ATTACHMENT 2 TO AEP:NRC:0896G

REVISED PAGES FOR THE

DONALD C. COOK NUCLEAR PLANT UNITS 1 AND 2

TECHNICAL SPECIFICATIONS

Figure 1

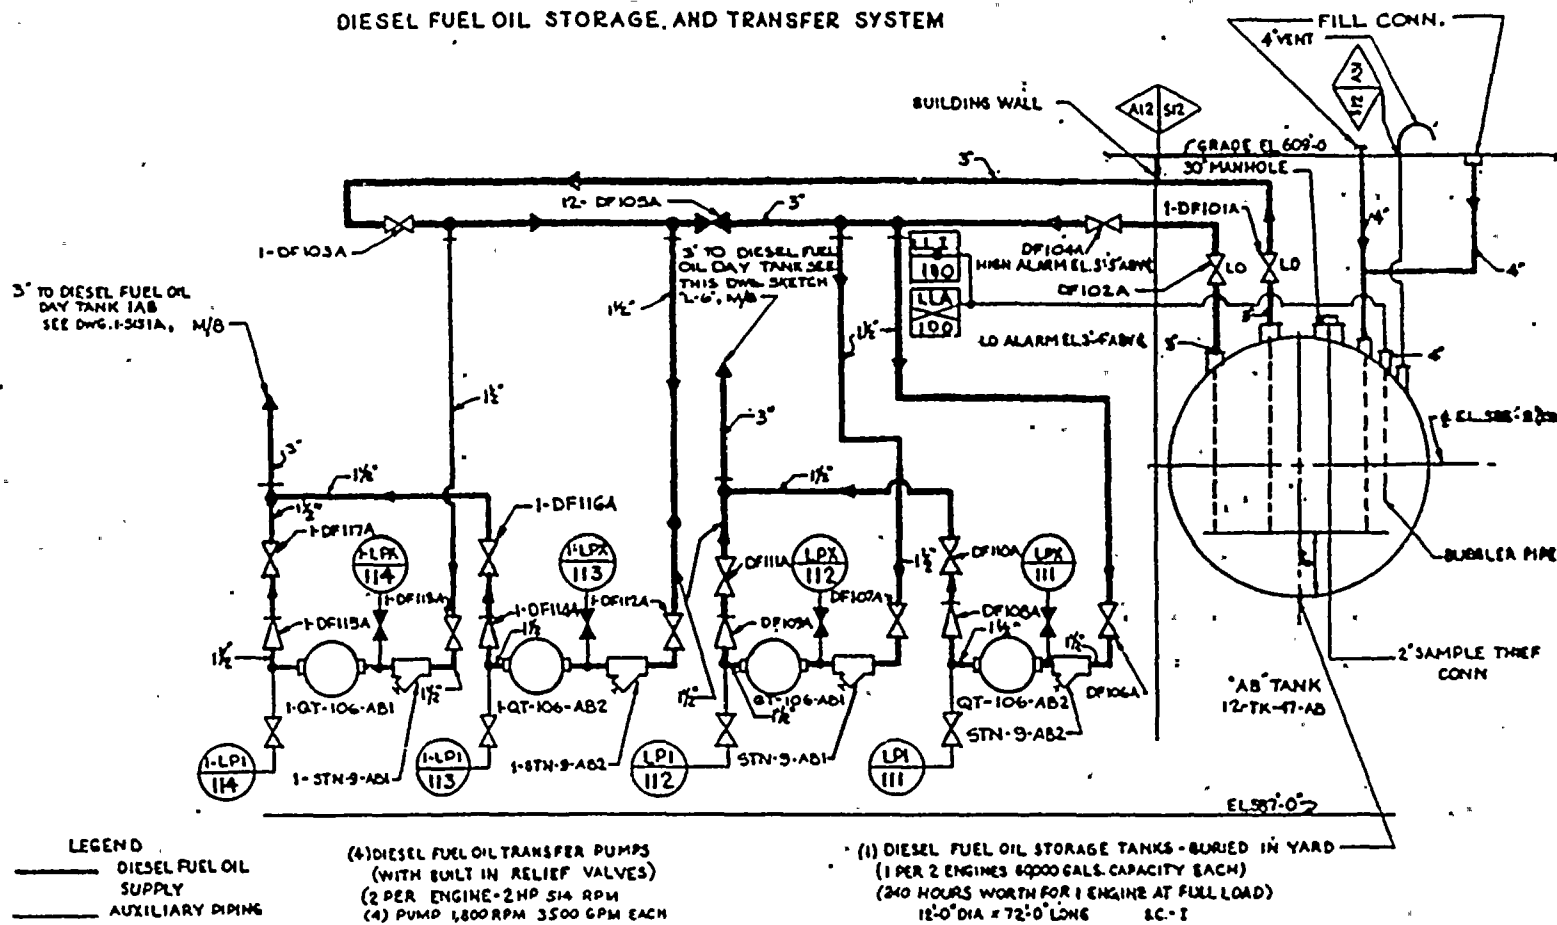
As shown on Figures 1 and 2, the "AB" tank supplies fuel to the Unit 1 "AB" diesel generator and the Unit 2 "AB" diesel generator, while the "CD" tank supplies fuel to the Unit 1 "CD" diesel generator and the Unit 2 "CD" diesel generator. Figure 3 shows the location of the tanks relative to each other. There is no cross-tie between the tanks; therefore, to empty either tank to clean it would require making a diesel generator in each unit inoperable. Since cleaning the tanks cannot be accomplished within the 72-hour Action Statement of T/S 3.8.1.1, emptying the tanks to clean them would require both units to be shut down.
